Request for Class II Permissive Change

FCC ID: VG8EM136AXX Data: 2012-5-13

Please be notified that we, the undersigned, Guangdong Midea Microwave and Electrical Appliances Manufacturing Co.,Ltd. declare that the reasons for this class II permissive change are as below:

Original Mainboard

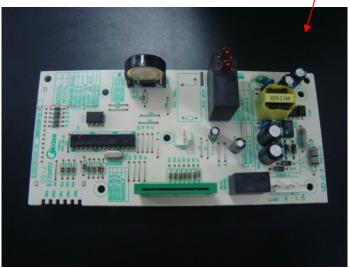
1. Updated Mainboard as below:

Changed linear power supply to switching power supply

or below switching power supply.

Between of linear power supply and switching power supply have the same specification of rated output power, changed to the switching power supply, theirs rated output power have not obvious change.

The differences of between this two switching power supply only is PCB layout and components location, anything else are the same.
